## **ADDITION TO SHADOW CREEK SUBDIVISION**

APPLICATION NUMBER 12 DATE July 5, 2007  
APPLICANT Addition to Shadow Creek Subdivision  
REQUEST Subdivision

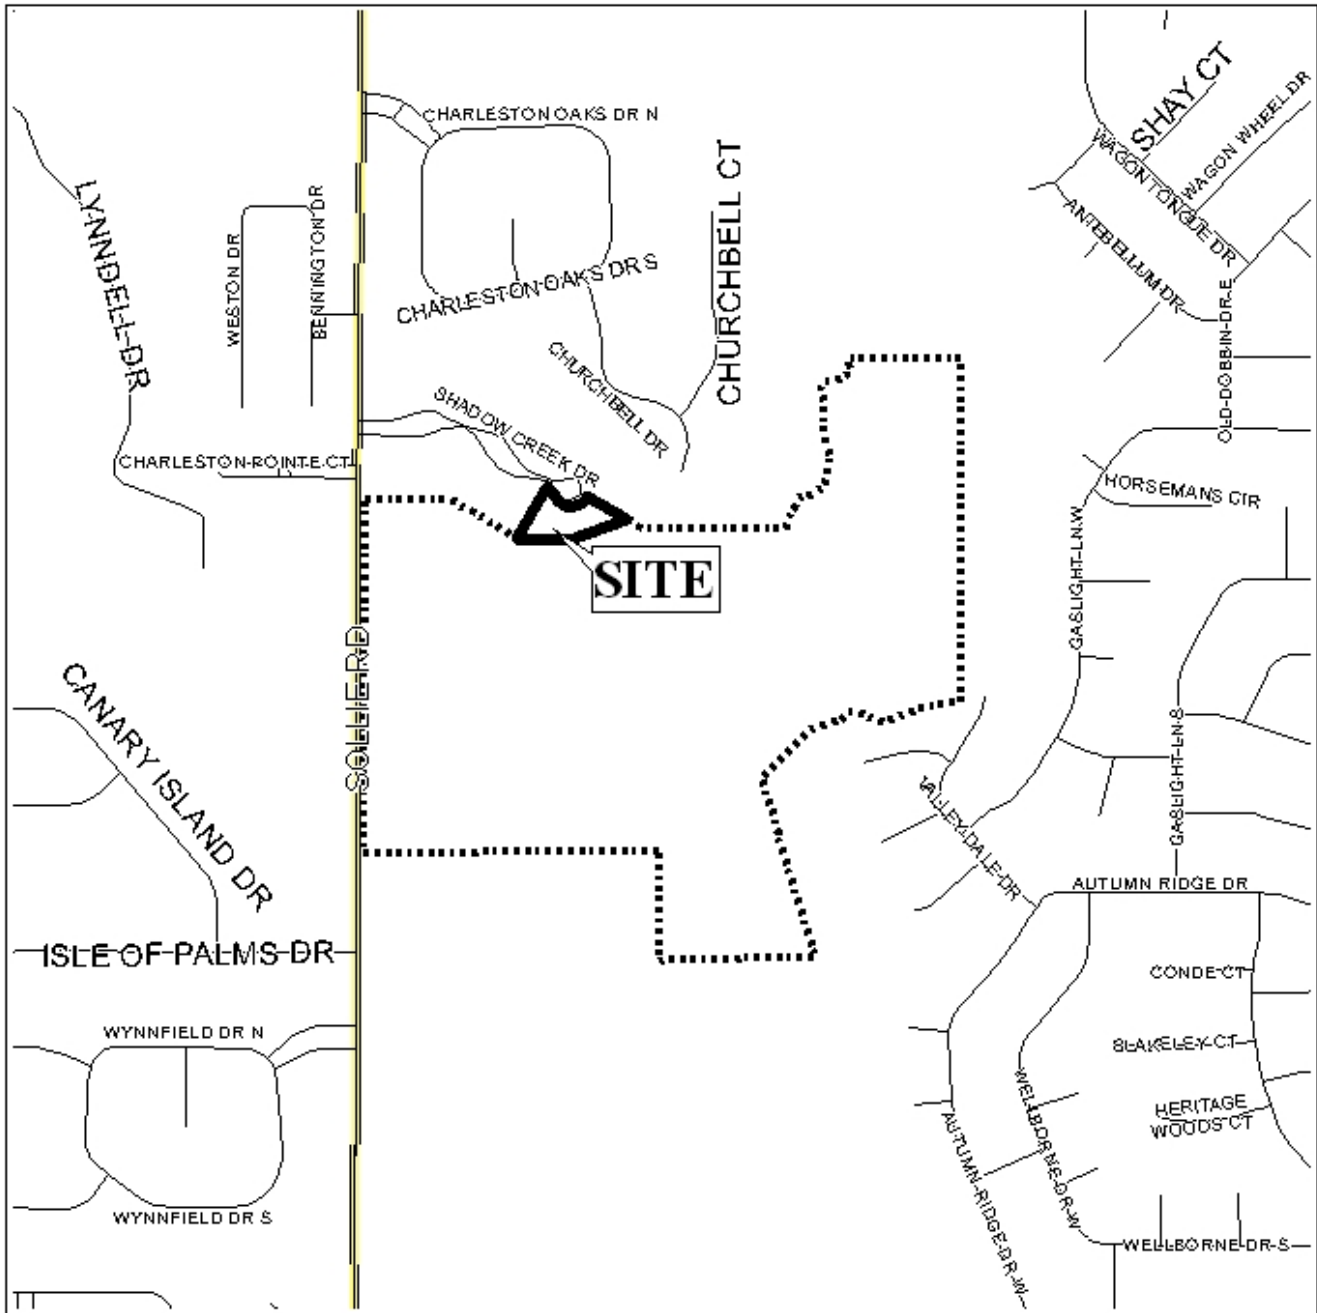
Both the proposed Lot 1 and the proposed Lot 2 have adequate frontage on Shadow Creek Drive, and neither of the proposed lots are corner lots. Shadow Creek Drive is a minor street with adequate right-of-way, therefore, no dedication should be required. Given the amount of street frontage as illustrated for each proposed lot, the site should be limited to one curb cut for each lot.

The plat illustrates the minimum building setbacks, and no change should be required.

The plat meets the minimum requirements of the Subdivision Regulations and is recommended for Tentative Approval subject to the following conditions:

- 1) placement of a note on the final plat stating that both lots are limited to one curb-cut to Shadow Creek Drive, with the size, design and location to be approved by Traffic Engineering and to conform with AASHTO standards; and
- 2) revision of the plat to label each lot with its size in square feet, or provision of a table on the plat with the same information.
